AS SUBDIVISION, EAST ADDITION

APPLICATION NUMBER 6 DATE March 20, 2014

APPLICANT AS Subdivision, East Addition

REQUEST Subdivision

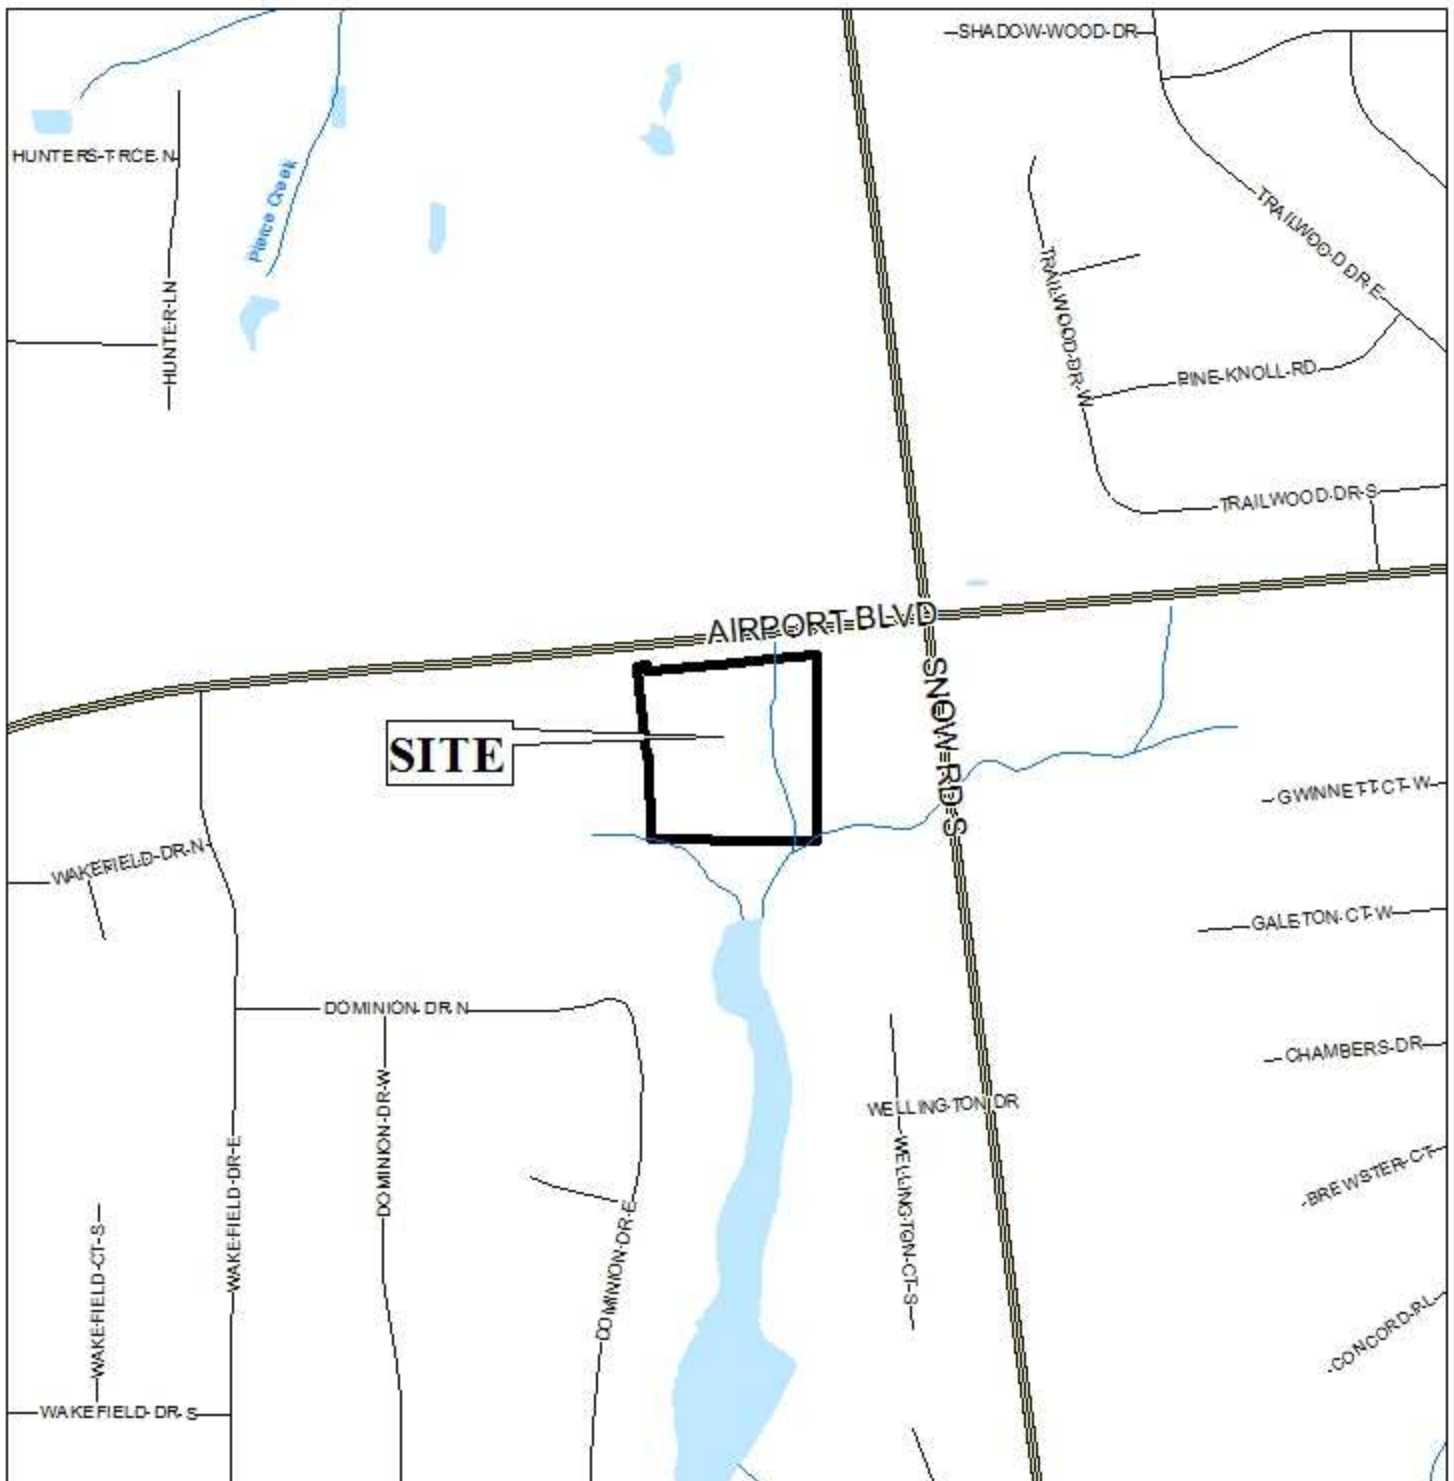
The site fronts on Airport Boulevard, a major street, as illustrated on the Major Street Plan with a planned 100-foot right-of-way. The plat indicates the right-of-way width on Airport Boulevard varies however, a 40' right-of-way width from centerline is illustrated on the plat, with an additional 32.01' labeled as a permanent easement and right of way line indicating a total right-of-way width of 72.01'. If approved, no additional dedication will be required and right-of-way widths depicted on the preliminary plat should be retained on the Final Plat.

The 25' minimum building setback line is indicated on a portion of the preliminary plat however it is not depicted along the entire proposed lot. The 25' minimum building setback line should be illustrated across the entire front portion of the property. Revisions should be made to depict the 25' minimum building setback line across the entire lot on the Final Plat, if approved.

It should be noted the lot size is labeled in square feet and acres; this should be retained of the Final Plat.

It should also be pointed out there is a note on the preliminary plat indicating a permanent easement located along the front property line, within the right-of-way.

- 1) placement of a note on the Final Plat limiting the lot to 2 curb-cuts with the location, size and design to be approved by Mobile County Engineering and to conform to AASHTO standards;

- 2) retention of right-of-way width as depicted on preliminary plat;
- 3) revision of the 25-foot minimum building setback line to include the entire lot on the Final Plat;

- 4) retention of the lot size in square feet and acres on the Final Plat;
- 5) placement of a note on the Final Plat stating that approval of all applicable Federal, state and local agencies is required for endangered , threatened or otherwise protected species, if any, prior to the issuance of any permits or land disturbance activities;
